REMARKS

Applicant respectfully requests reconsideration of the present application in view of the foregoing amendments and in view of the reasons that follow.

FIG. 4

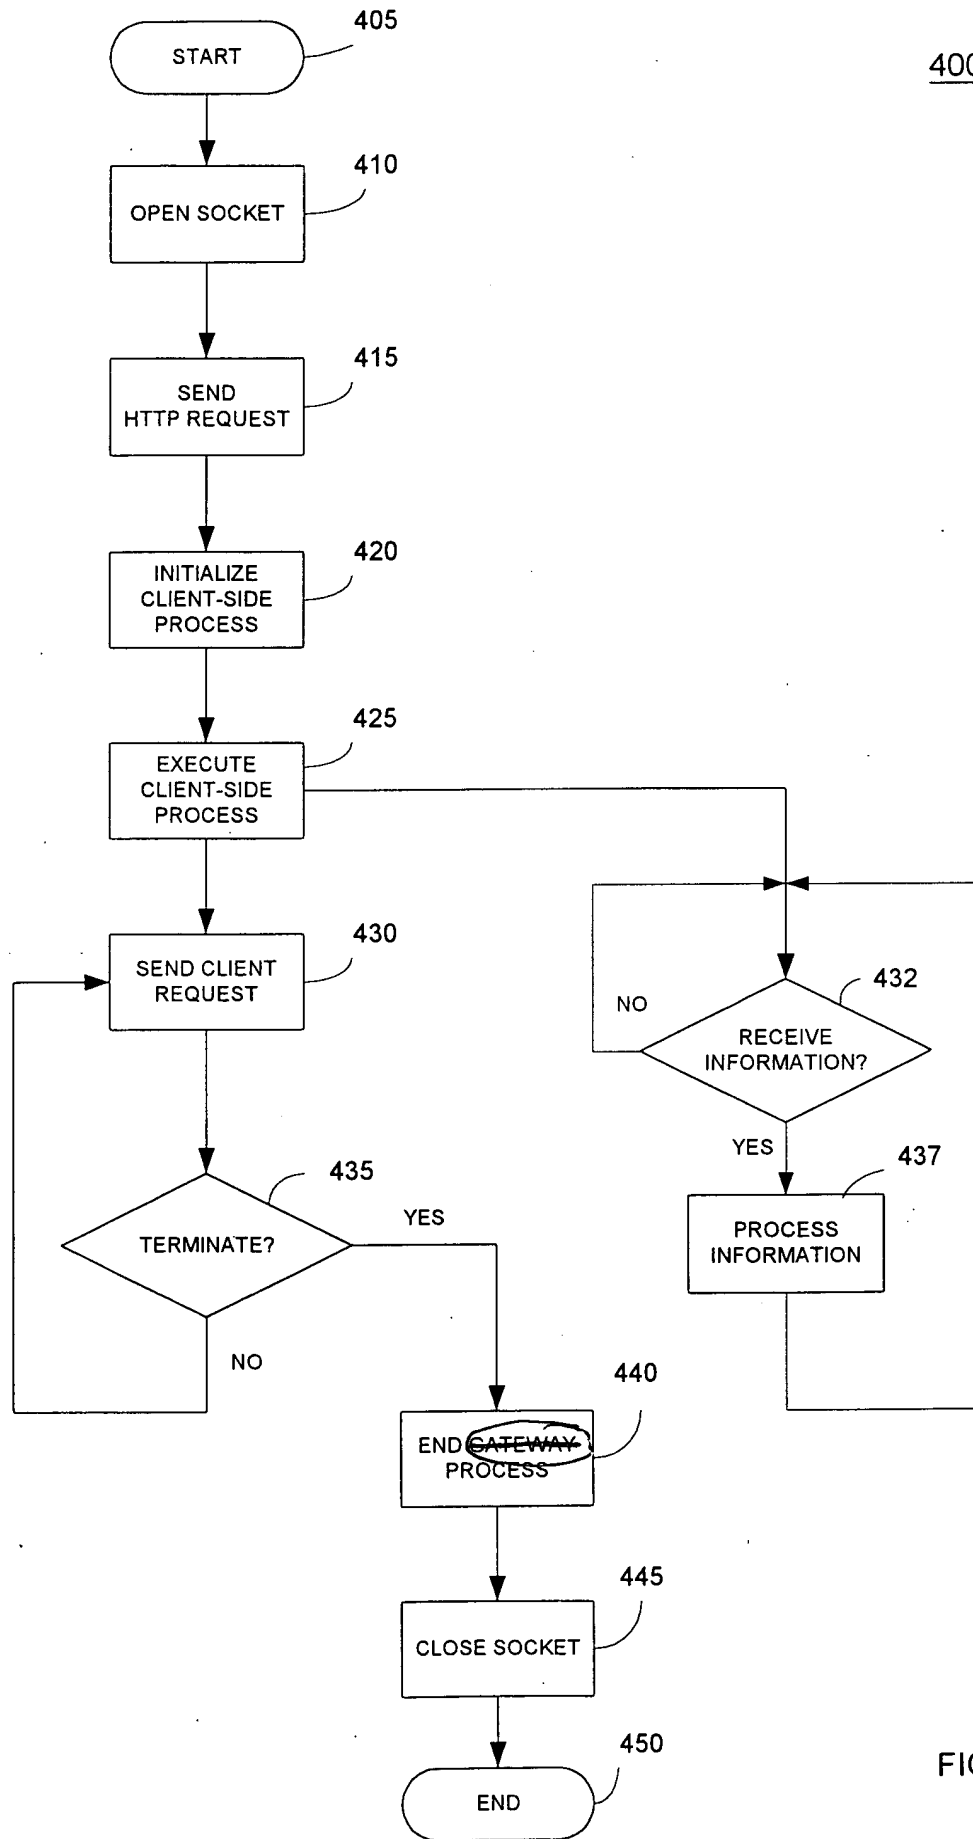
The drawings are objected to for certain informalities. Applicant is submitting a replacement drawing sheet including a corrected Figure 4. The block 440 has been amended as suggested by the Examiner.

The specific changes which have been made to Figure 4 are the removal of the word “gateway” from block 440.
